**ATEC**  
FRAMEWORK DEVELOPMENT PLAN  
AURORA, COLORADO

Sheet Title  
CONTEXT MAP

MASTER PLAN NARRATIVE

PUBLIC IMPROVEMENT PLANS  
PLANNING AREA 3 - INFRASTRUCTURE

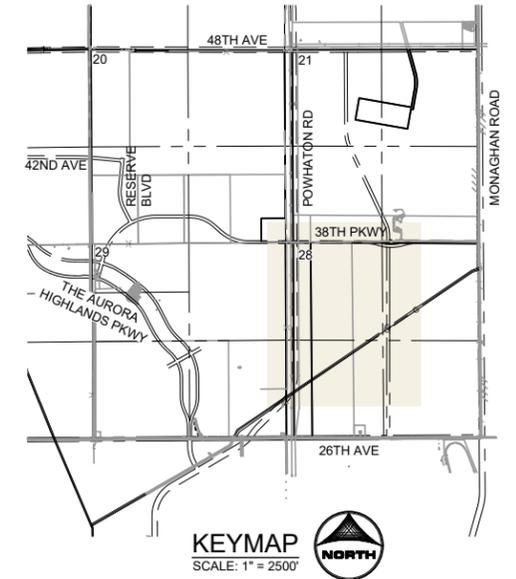
The Powhatan Road alignment needs to be consistent with TAH PIP. Improvement needs to be shown, but indicated to be done by TAH? Again addressing if PA-4 develops prior to TAH triggers for Powhatan

**THE ALIGNMENT OF POWHATON ROAD IS CONSISTENT WITH THE APPROVED TAH PIP. LANGUAGE HAS BEEN ADDED TO REPORT FURTHER EXPLAINING PHASING.**
